NOTICE OF DECISION

RE: DR97-82-E (PDR-2024-00094): Burk Plaza – CSP Amendment

Staff has reviewed the exhibits for a Minor Comprehensive Sign Plan Amendment application for Burk Plaza located at the southeast corner of Burk Street and Baseline Road and zoned General Commercial (GC) with a Planned Area Development (PAD) overlay. The proposal consists of modifying the sign plan to allow for signage along the west elevation of the ABC Dentistry for Children building addressed 2357 East Baseline Road. A general summary of the proposed request is listed below:

WEST ELEVATION

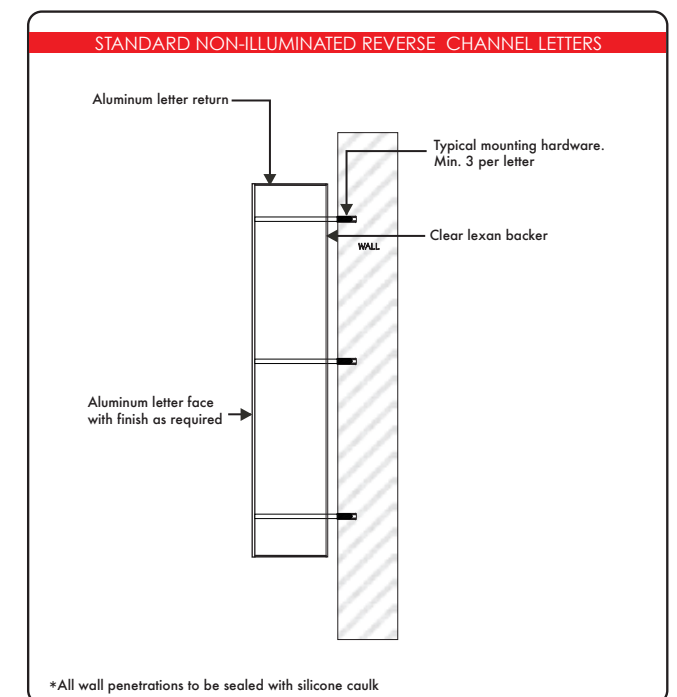
Because of the ambiguity in the LDC relating to the definition of “abutting,” in the case of the sign proposed on the western side of the building, we must apply the above factors to determine the proper location of the sign. Specifically, allowing the western wall sign to follow the general height requirement of Table 5.6.11.E.1 would not run afoul of any of the following factors:

- a. *Whether the location and placement of the sign will endanger motorists.*
 - a. No, the location and placement of a sign at 18’ 6” in height will not endanger motorists because its placement on the wall is not near any roadway.

- b. *Whether the sign will cover, blanket or interfere with any prominent view of a structure or façade of architectural significance.*
 - a. No, the height of the sign will not cover, blanket, or interfere with any prominent feature. To the contrary, the placement of the sign directly above the doorway arch may, in fact, ensure that the sign does not detract from the architecture of other buildings within the development.

- c. *Whether the sign will obstruct views of users or abutting buildings to landscaped areas or open space.*
 - a. No, the height of the sign will not obstruct views of any landscaped areas or open space because, as proposed, the sign will sit flush against the wall of the building to reduce any potential obstruction.

- e. *Whether the sign is compatible with nearby building heights.*
 - a. Yes, other buildings in Burk Plaza contain wall signs at a similar height and direction to the proposed signage.

- a. Based on the amended application, the sign will not be illuminated and therefore, it's illumination will not cause a hazardous or unsafe driving condition.

Based on the above analysis, the proposed sign height of 18' 6" is consistent with the purpose and intent of the Town sign code. Under the amended application, the sign area and illumination requirements adhere to the general and special criteria for "when abutting property for residential use." Because both criteria are met, there is no need for a discretionary finding here. Should the applicant propose that the sign be illuminated, or the sign area be changed, those changes must be addressed individually.

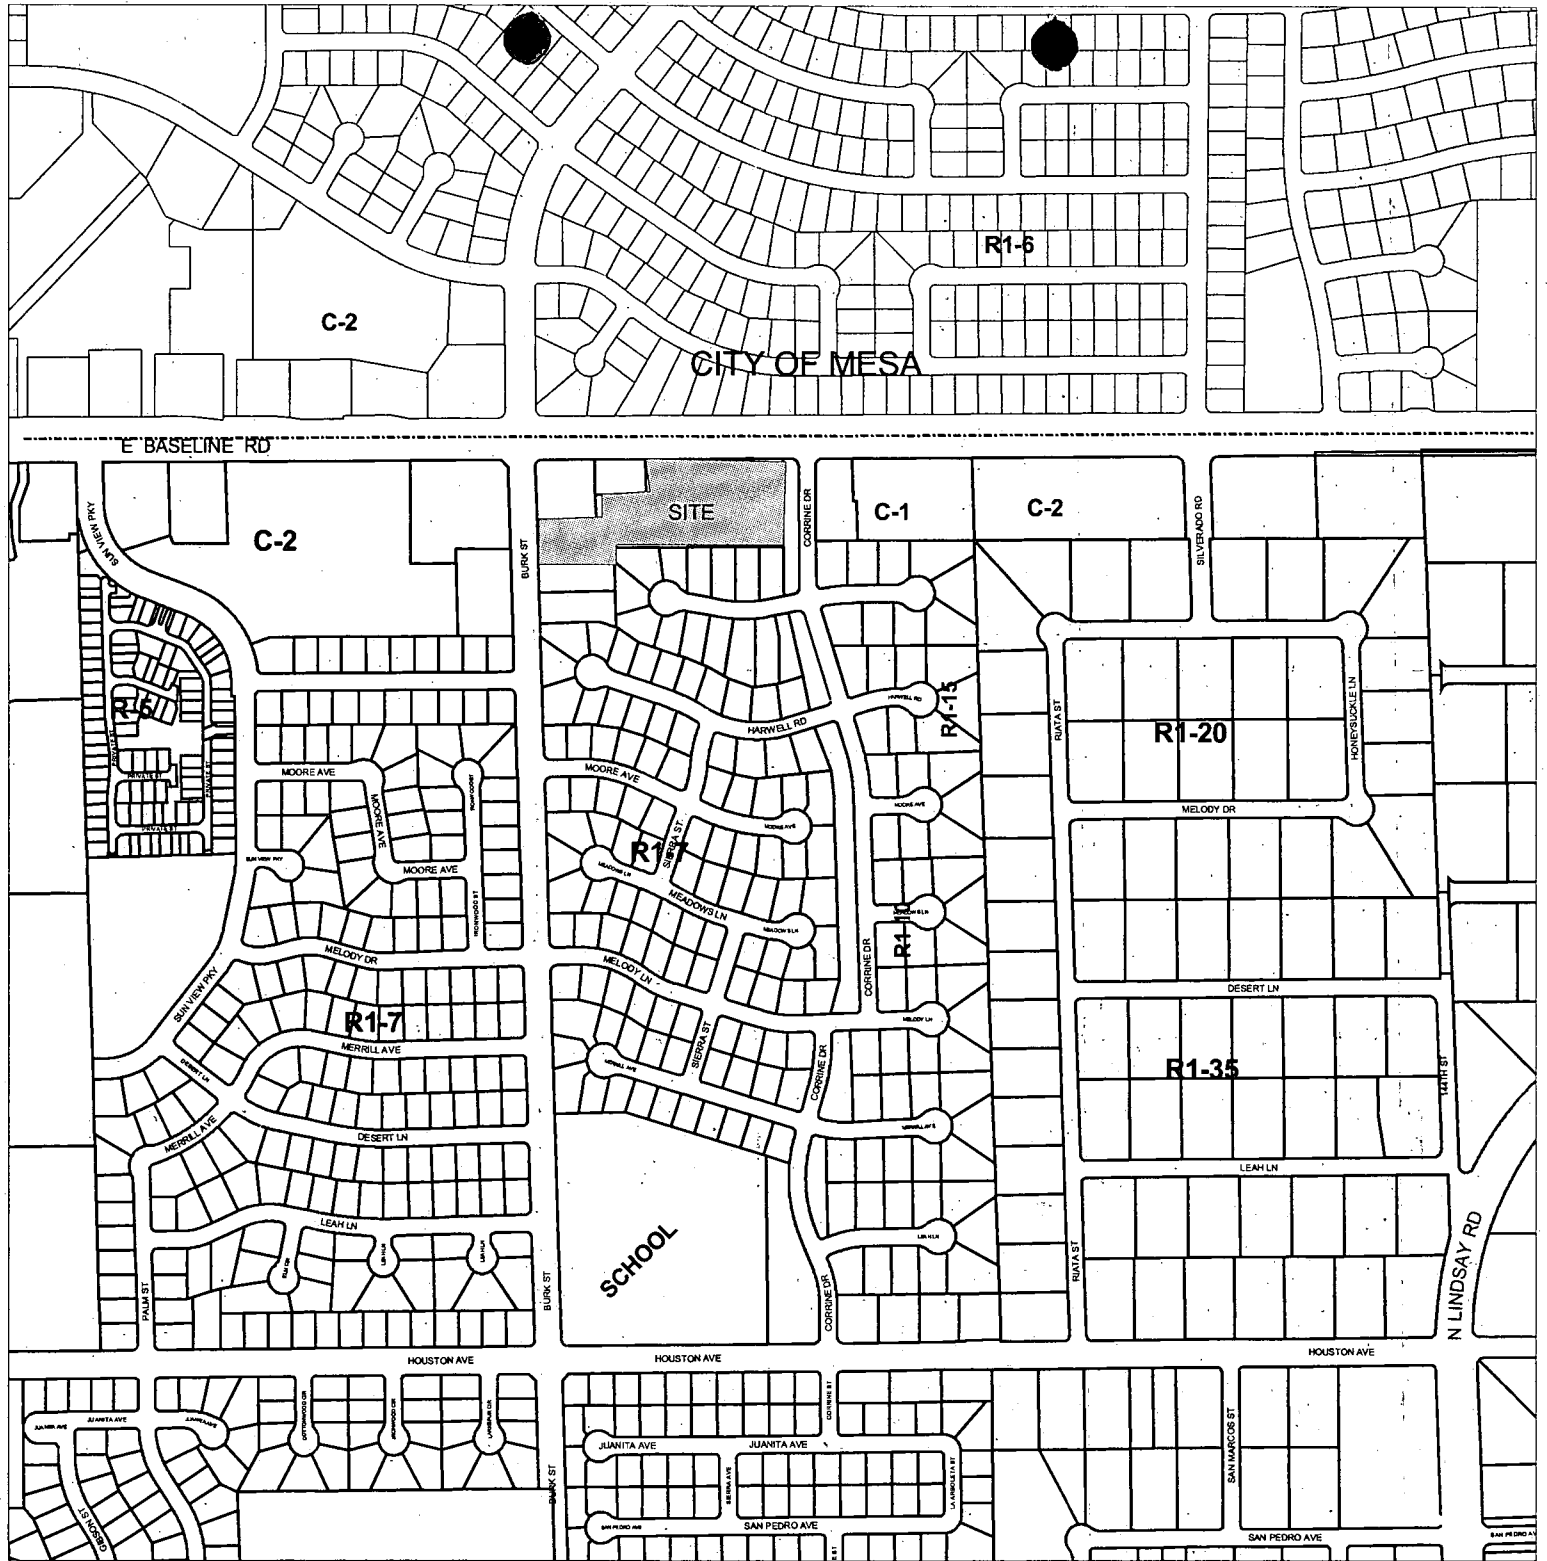
Monument Signs: As proposed, the site plan illustrates the placement of three (3) freestanding monument signs (Exhibit B). One (1) freestanding monument sign is proposed adjacent to Burk Street for the Phase II Pad, located between the existing AM/PM convenience store and the existing Cobre Tire automotive store. The remaining two (2) freestanding monument signs are proposed adjacent to Baseline Road to address the signage needs of Phase I and Phase II of the project. Design of the signs is consistent with the design and colors used on the center by replicating the gable treatment and previously approved color palette into the design of the signs. Additionally, placement of the signs is approximately three-hundred (300') feet apart which meets the Unified Land Development Code (ULDC) requirements. However, the western most monument sign proposed adjacent to Baseline Road does not meet the three-hundred (300') distance requirement from the existing Econo Lube N' Tune. Staff believes that this proposed location does not present any adverse issues due to the allotment of freestanding signs for each property owner. Furthermore, the proposed monument sign adjacent to Burk Street is proposed approximately sixty (60') feet from the existing AM/PM freestanding signage. Although these are two separate properties, Staff recommends to provide more separation between the existing and the proposed freestanding monument sign adjacent to Burk Street. Staff further recommends

As provided with Exhibits' E-1 through E-4, sign criteria has been outlined in general requirements, specifications, and design requirements. Staff supports the aforementioned sign criteria however, Staff can not support the proposed black color as a primary color for the

signage. Staff believes that this proposed color is not complementary to the existing color palette for the center. However, Staff can support the use of black as an accent or trim color.

3. Freestanding signage adjacent to Burk Street shall provide center identification 'Burk Plaza', at the top one-third (1/3) of the sign.
4. Each freestanding sign shall not exceed sixty-three (63) square feet in area, nor eight (8') feet in height. Said height of signs shall be measured from the top of curb of the parking lot. Calculations for area shall not include architectural embellishment proposed at apex of sign.

5. The freestanding monument sign adjacent to Burk Street shall be repositioned approximately eighty (80') feet to the south to provide an approximate separation from the existing AM/PM sign of one-hundred fifty (150') feet.
